DAUPHIN COUNTY SUBDIVISION/LAND DEVELOPMENT REVIEW REPORTMunicipality Swatara T. Surveyor Hoover Engineering Engineer Plat Title 1031 Eisenhower Boulevard P/F LD and SD PlanZoning District CG – Commercial General Proposed Land Use Restaurant/ Pool Hall

Reviewed by GD Checked by ARK Parcel ID 63-062-068**Project Description** Construct a 5,160 SF building to be used as a pool hall. .

No. 25-115

PRELIMINARY / FINAL
LAND DEVELOPMENT AND SUBDIVISION PLAN
FOR
**1031 EISENHOWER
BOULEVARD**
SWATARA TOWNSHIP, DAUPHIN COUNTY, PA.

**EXISTING FEATURES /
SUBDIVISION PLAN
FOR
1031 EISENHOWER
BOULEVARD
SWATARA TOWNSHIP, DAUPHIN COUNTY.**

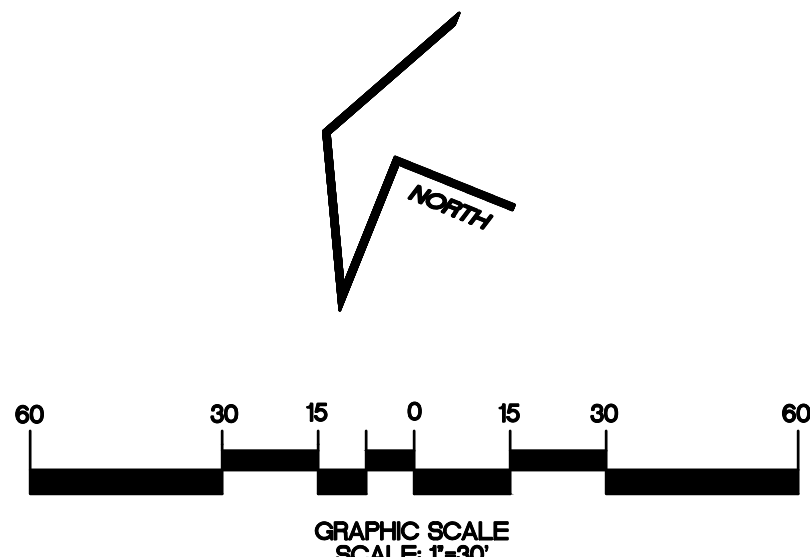
1. The plan appears to be the consolidation of two lots into one lot containing two structures. However, it is unclear whether these constitute two distinct buildings or a single connected structure. Clarification is needed, as this distinction could impact building code requirements, expansion of non-conforming items (ie setbacks) and future redevelopment considerations as it relates to the adequacy of parking provisions on the site.
2. While the plan appears to satisfy the lot coverage and green space requirements, this is primarily achieved through areas that are not centrally located or adjacent to the developed portion of the site. Has consideration been given to incorporating green infrastructure or planters within the parking area to enhance both stormwater management and the visual appeal of the site?

SHEET **LD 3**

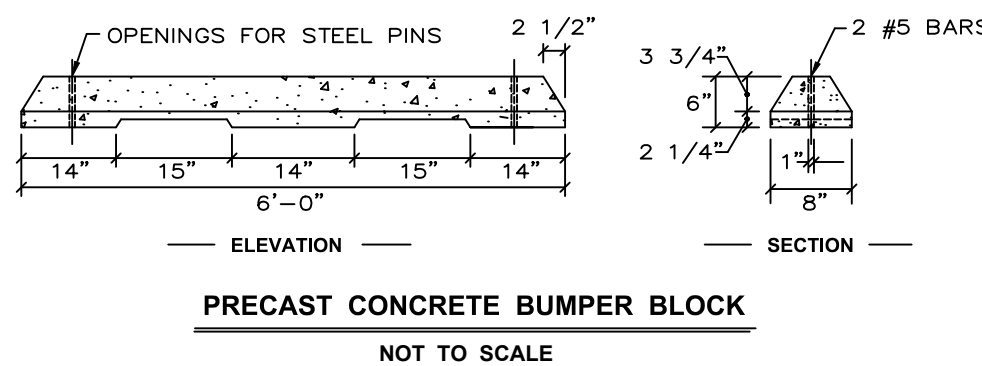
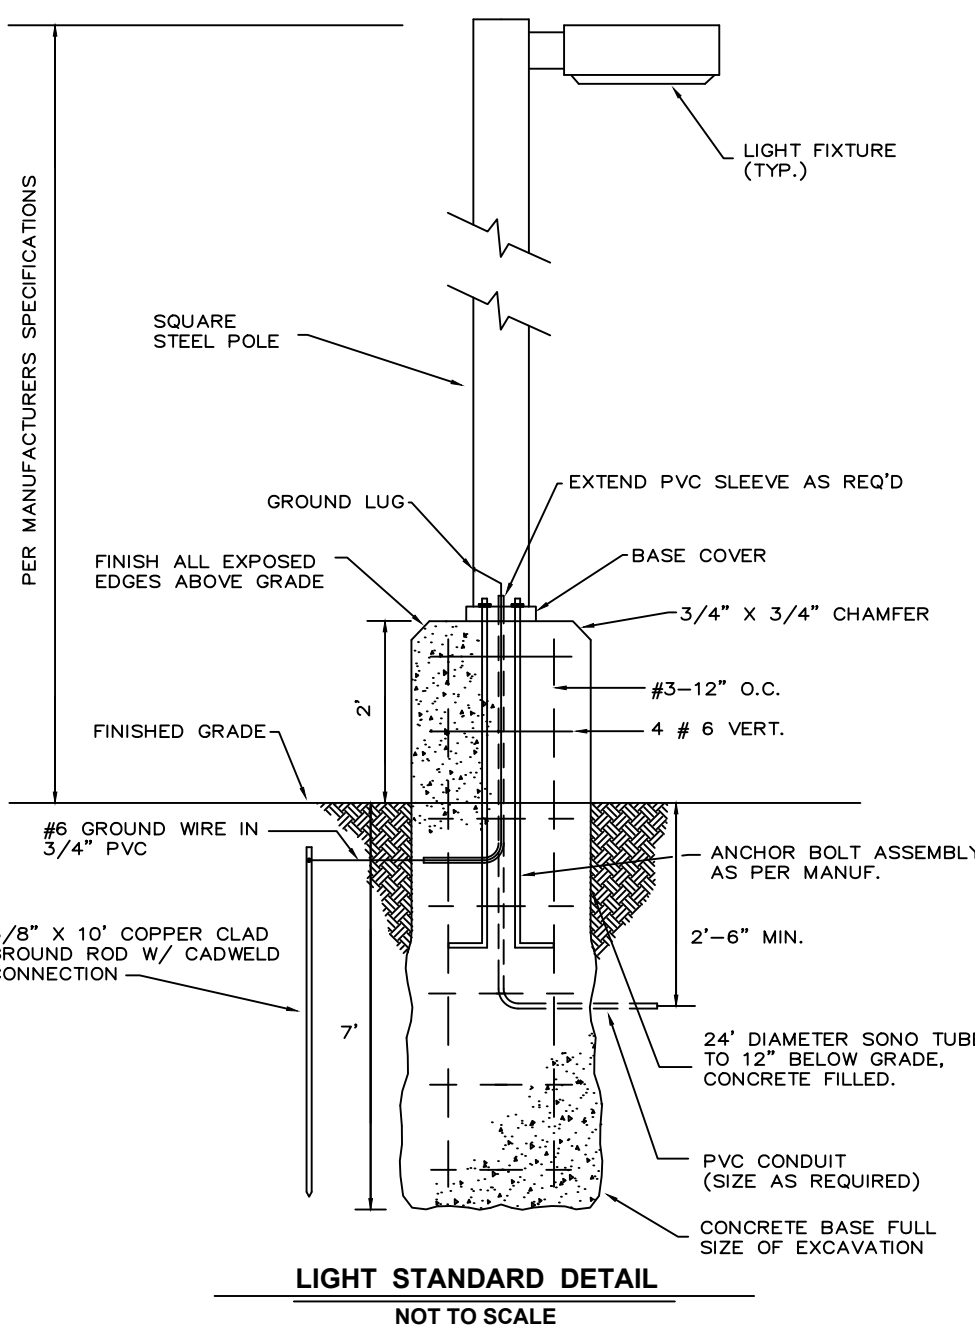
3. The proposed driveways must comply with S&LDO §253-16 and should be reviewed by the Township Engineer to ensure compliance. It is unclear whether the driveways are intended to be full-access or configured as one-way (e.g., one entrance and one exit), as the internal traffic patterns suggest such a design. However, the plan lacks clarity regarding striping and signage, which should be addressed to confirm the intended traffic flow.

1. No lighting plan has been provided. Although the notes indicate that no new lighting will be installed and only existing fixtures will be relocated, the inclusion of lighting pole details suggests that new lighting may be proposed. If the redesign of the driveway and parking areas requires modifications to the existing lighting, compliance with applicable zoning provisions must be demonstrated
